top view

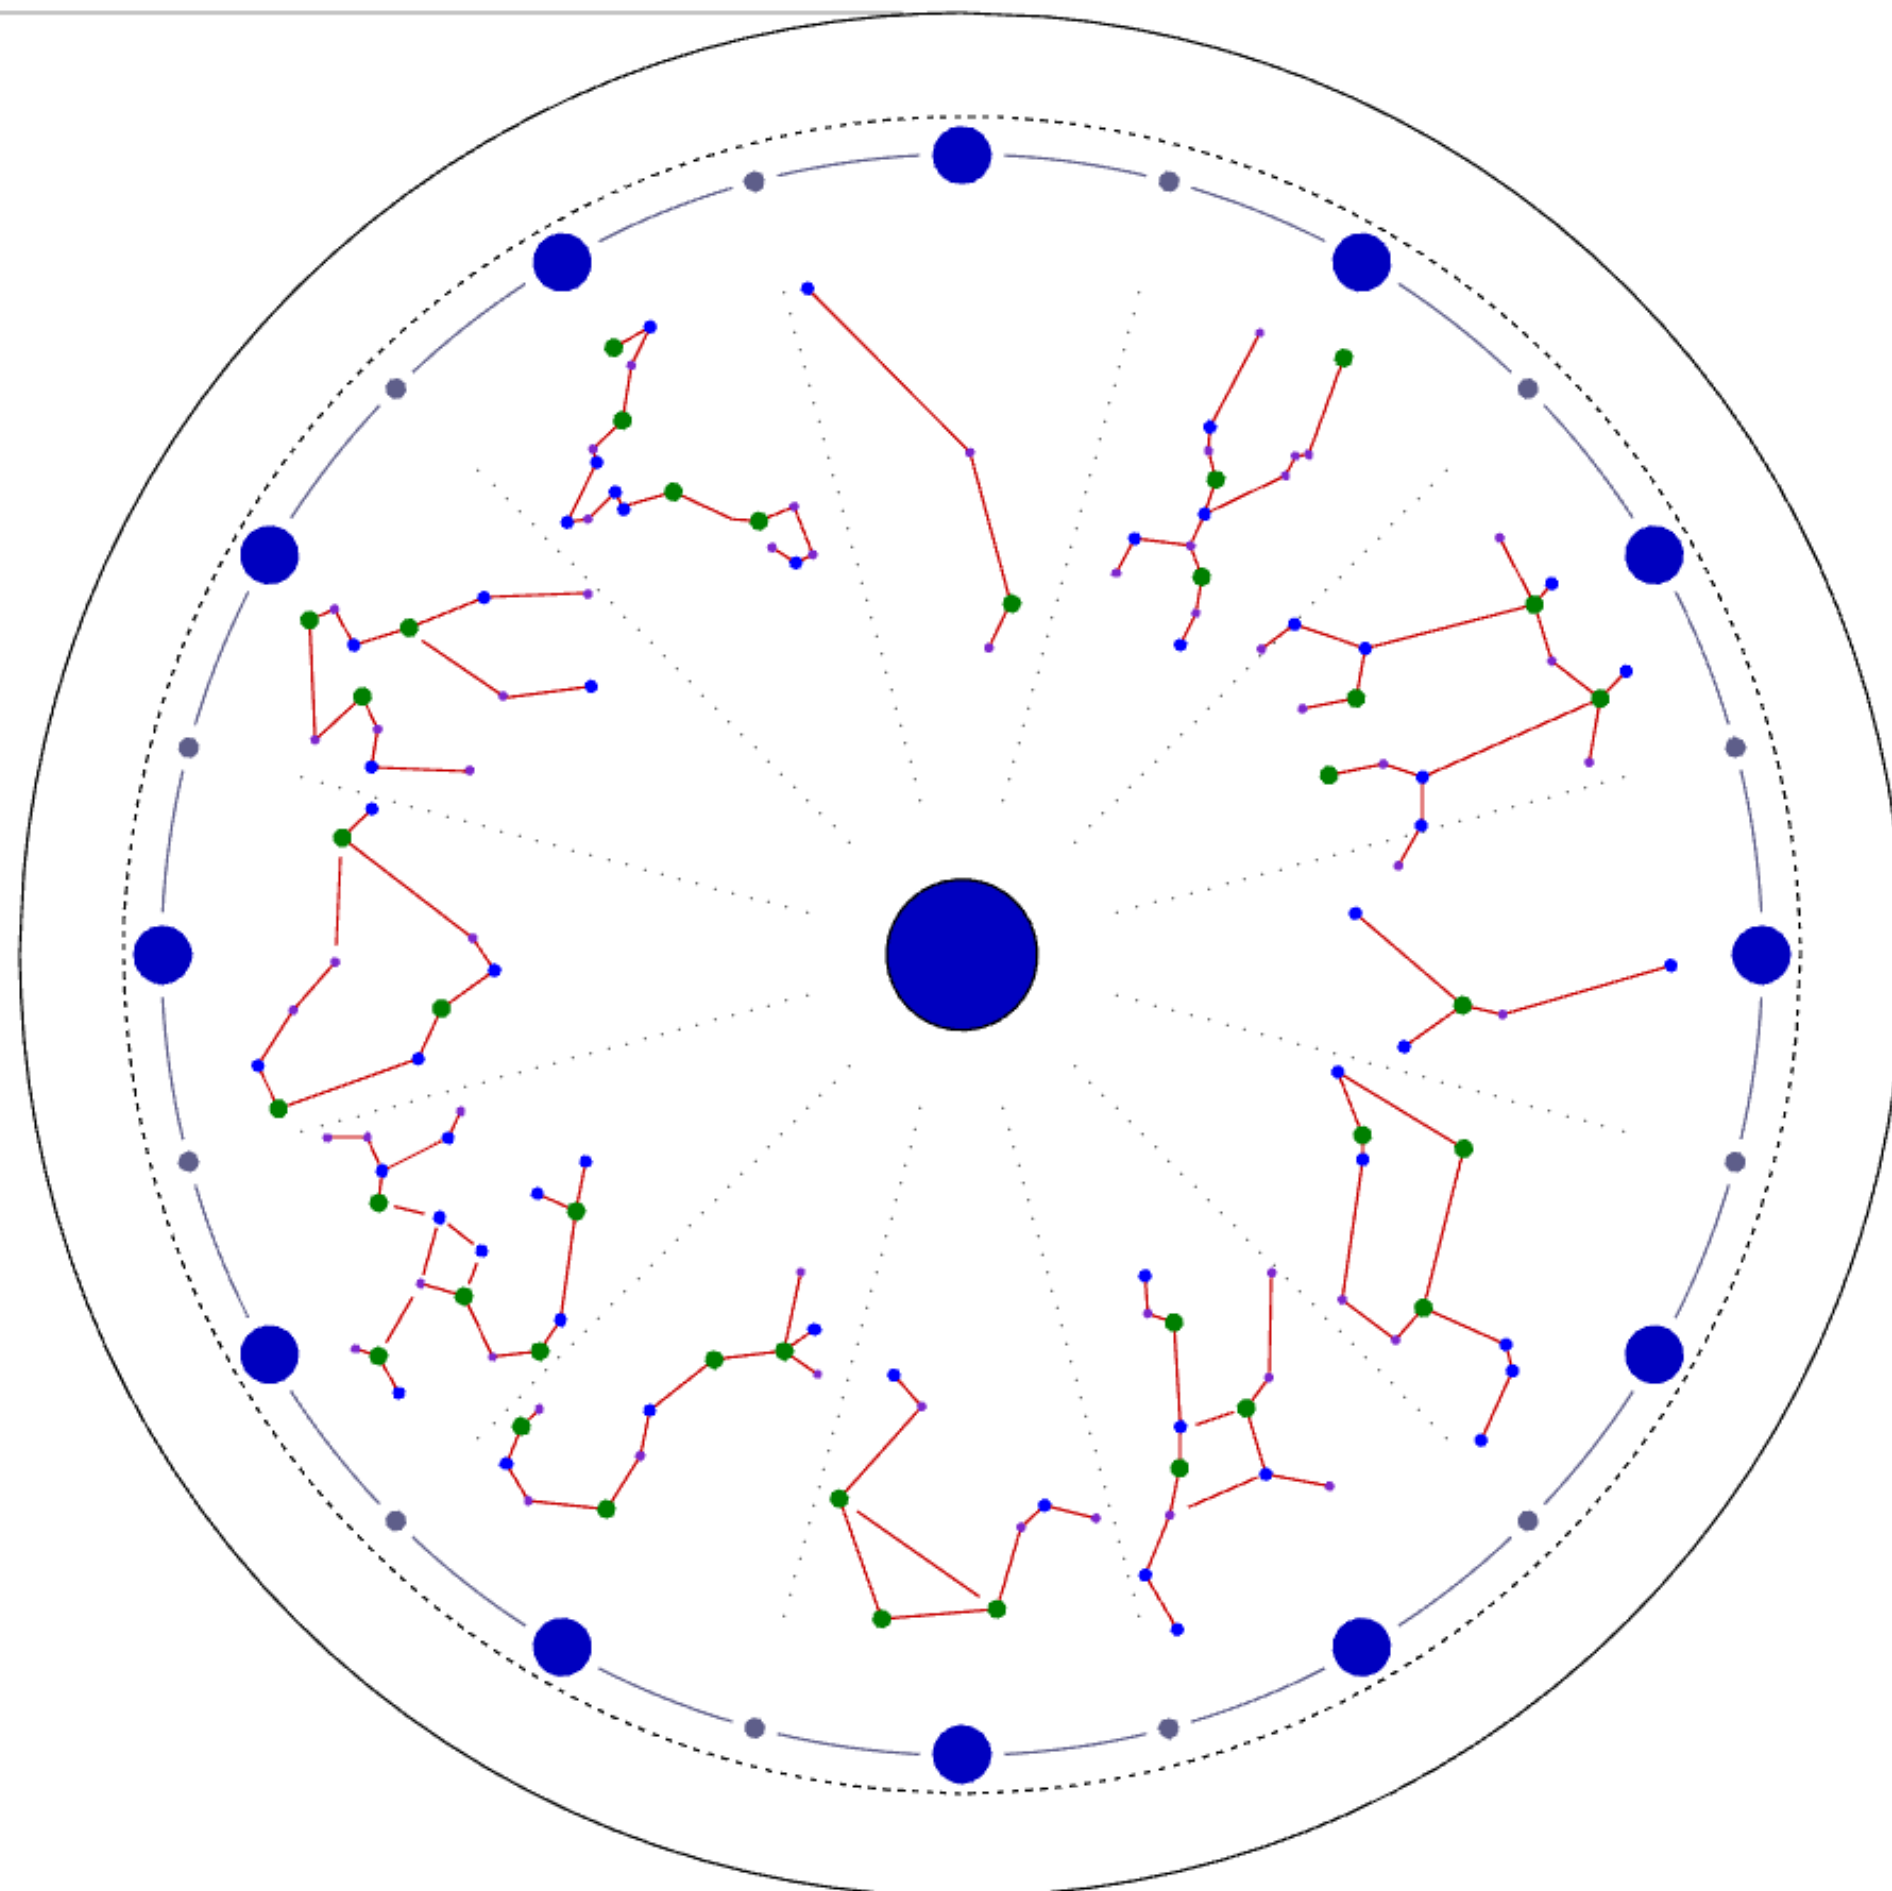
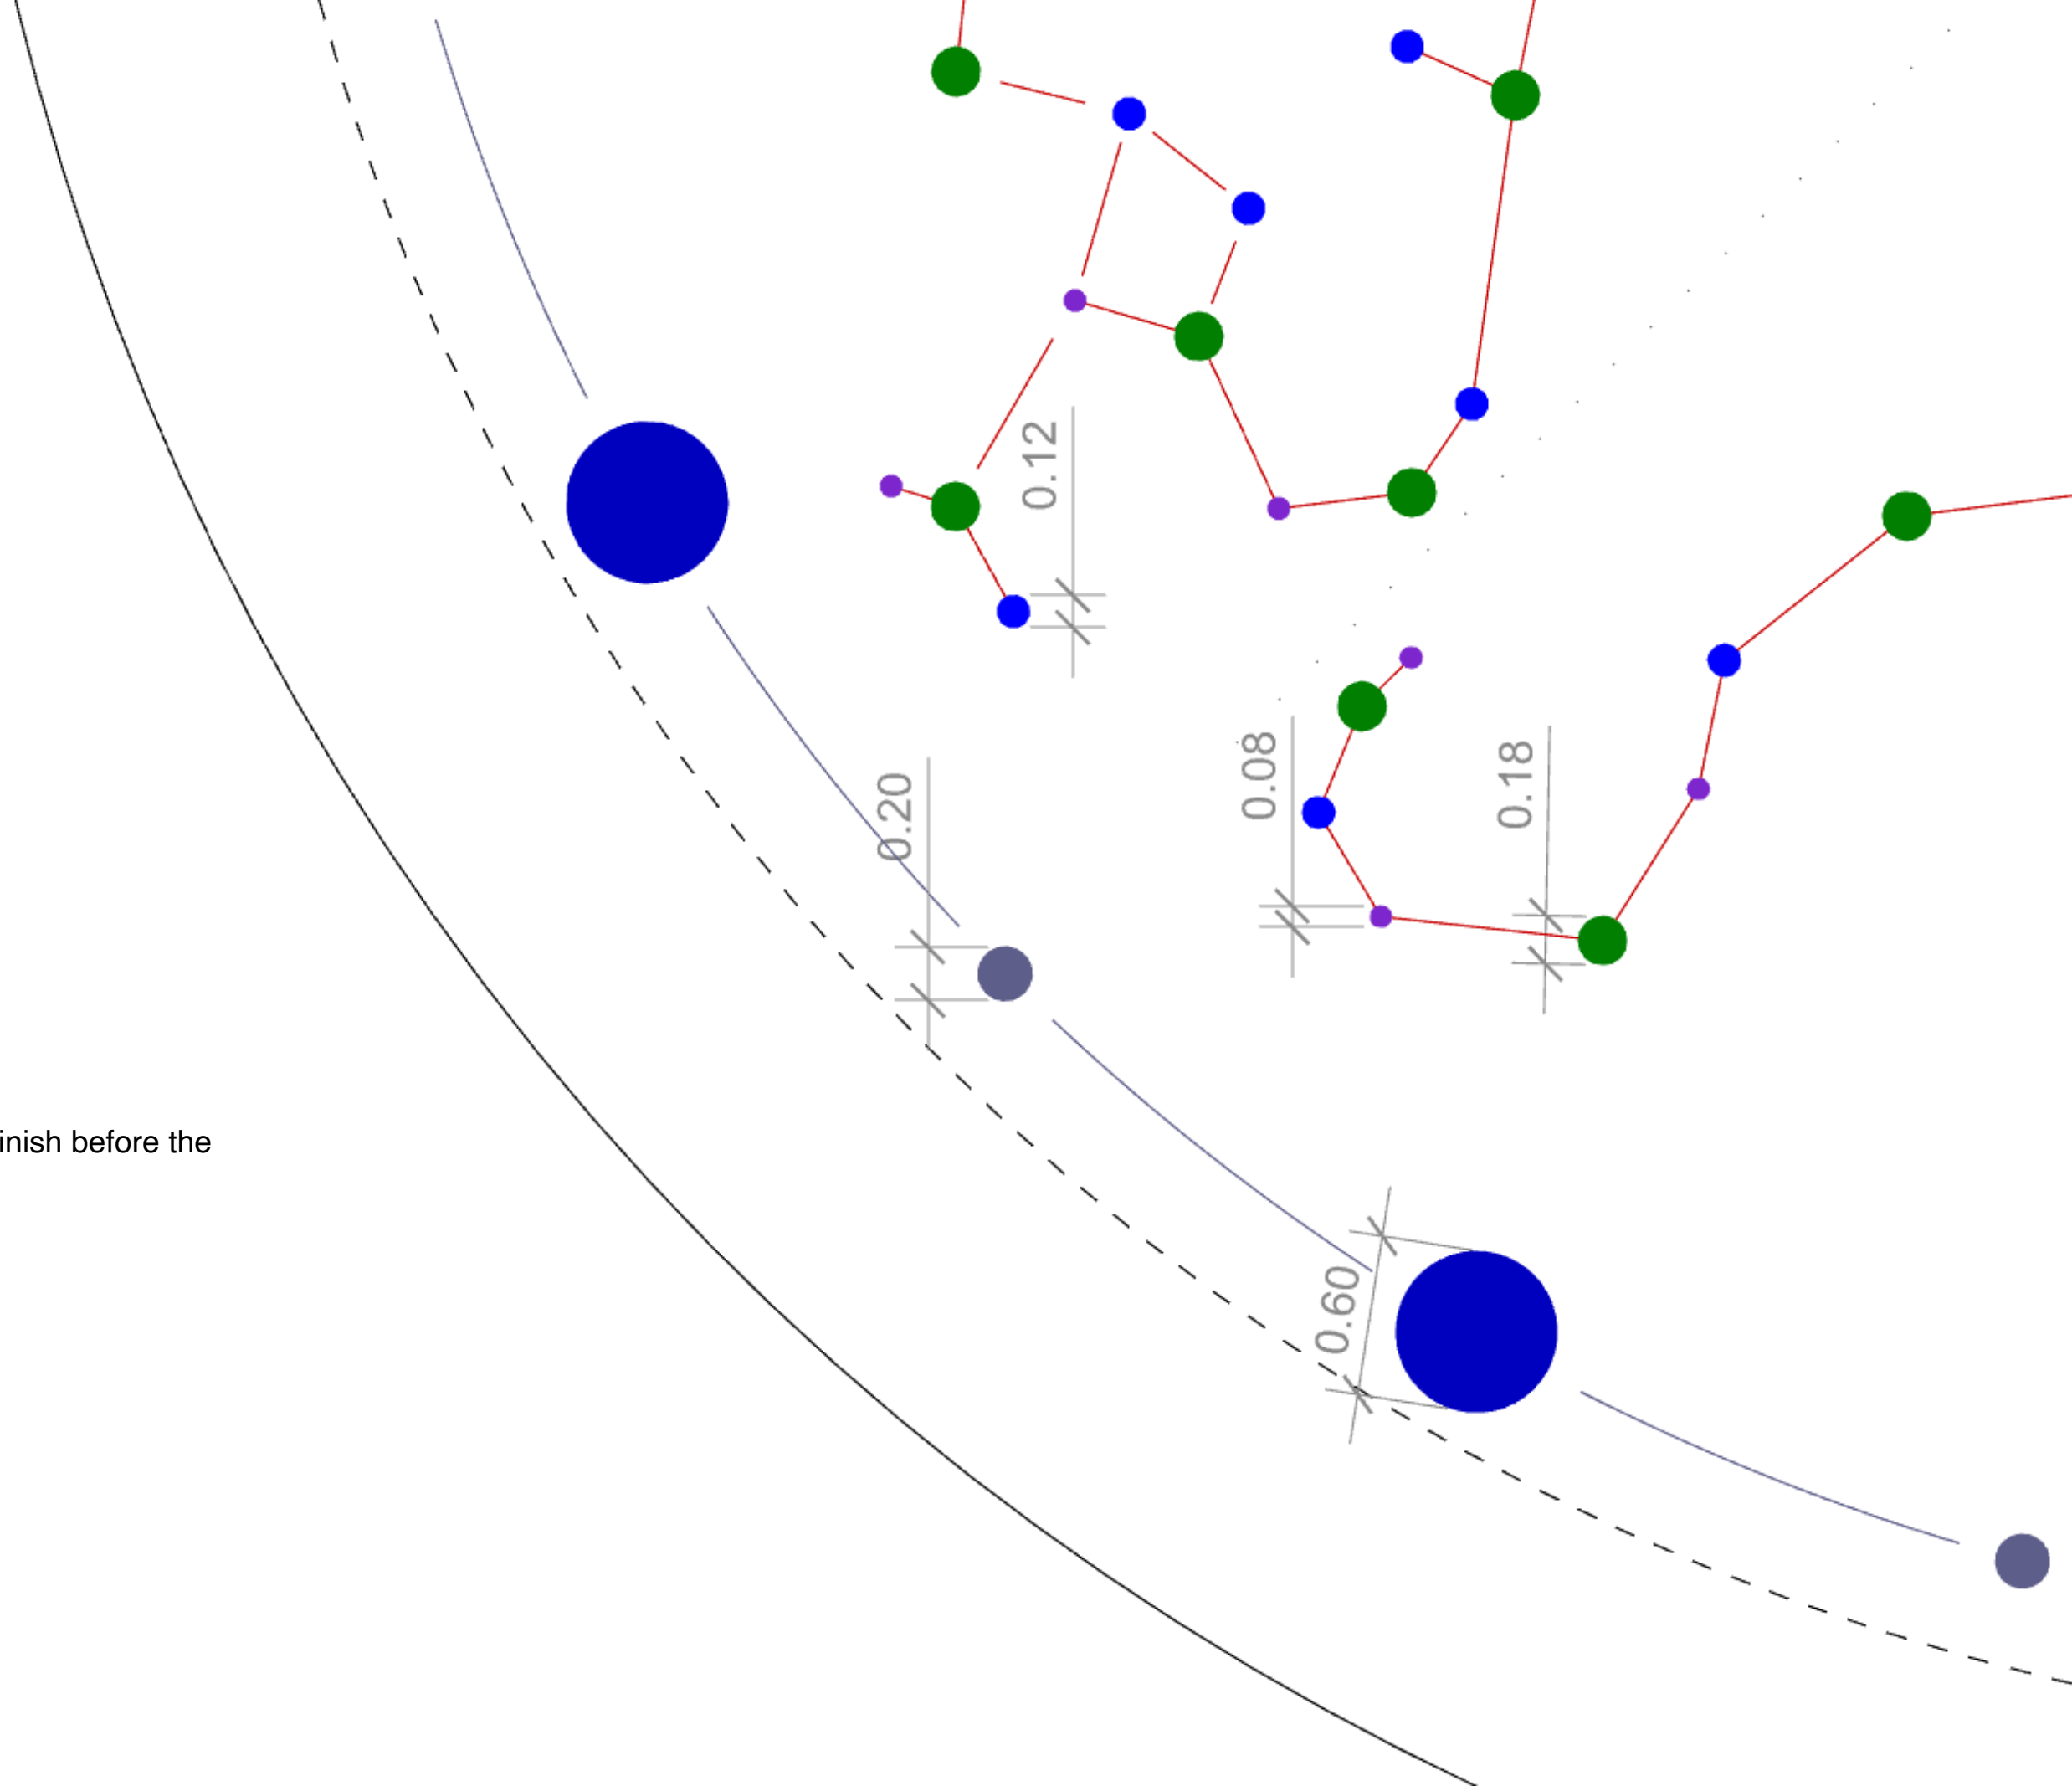
- constallation lines minimum thickness?
- constallation lines continuation, should they all finish before the stars?
- circle stars size?
- minute line thickness?
- hours dots size?
- treatment of hour zones divisions?
- treatment of clock centre - earth?

horizontal section

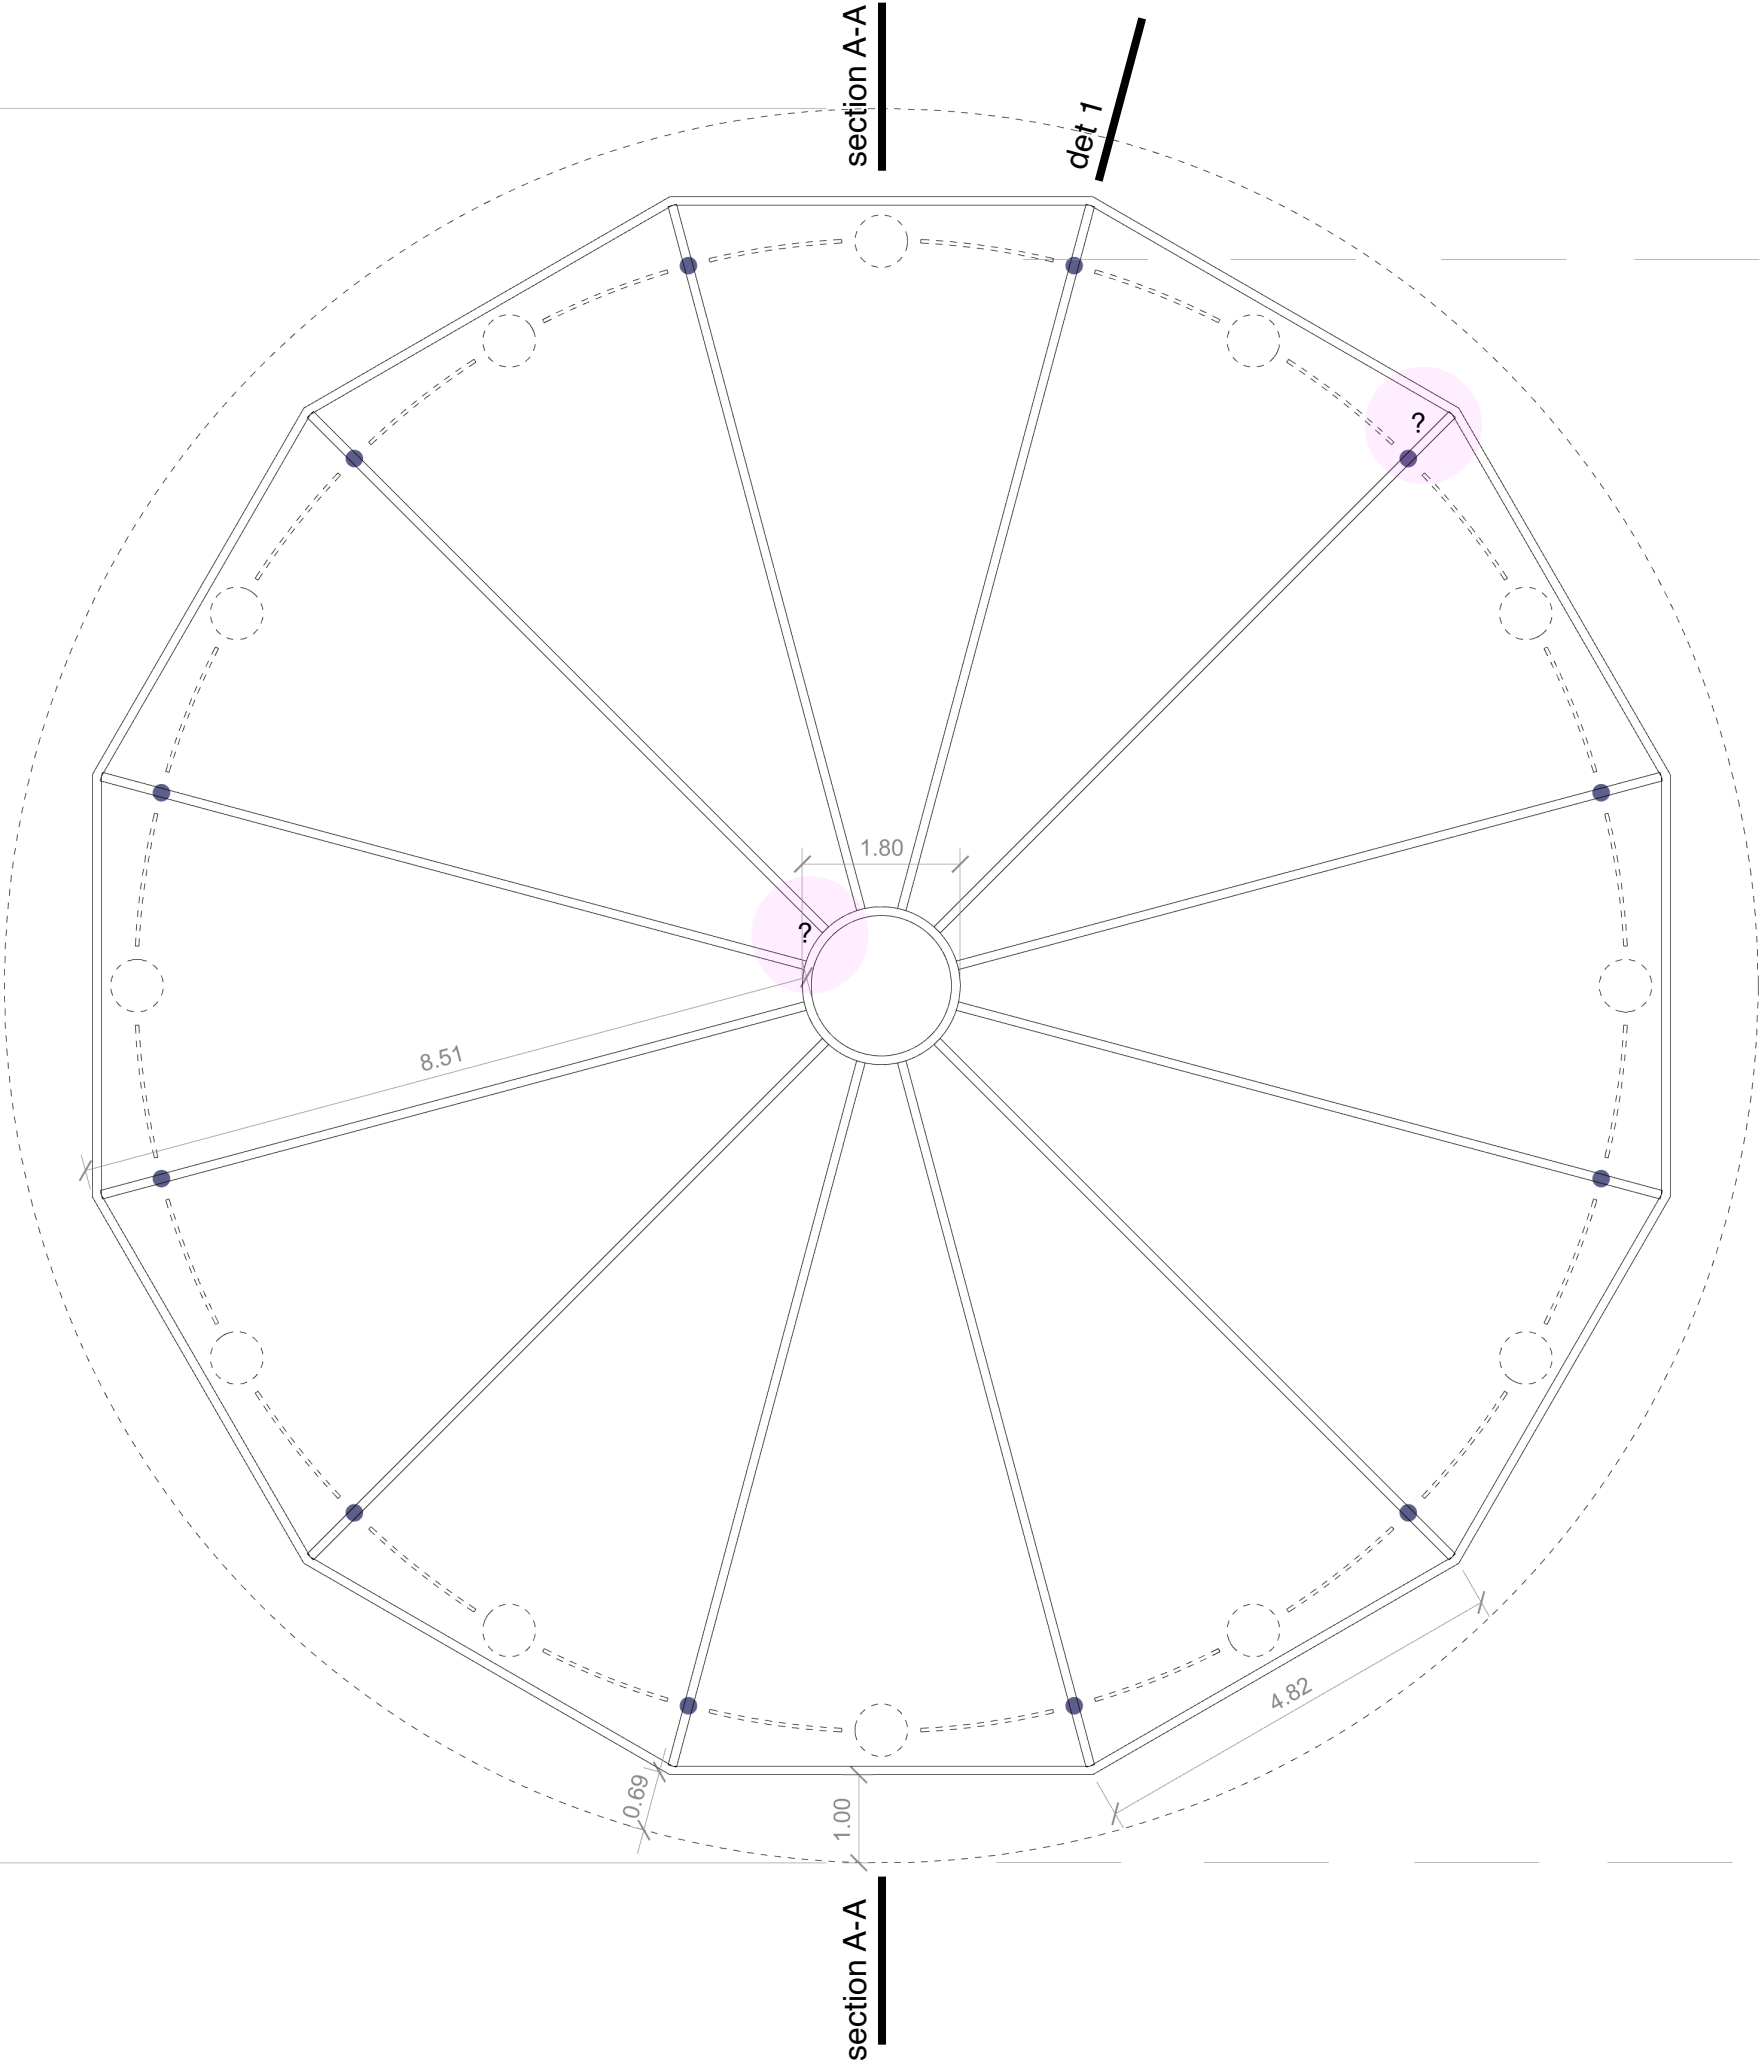
boundary surface, should it be cirzular or is it easier to be polygon?

is it becoming to big the clock, maybe we can try to scale the constallations and place them closer to the middle (it really depends of the line thickness minimum and star size minimum we can achieve.

overhanging edge maybe is too small now and not hiding enough?
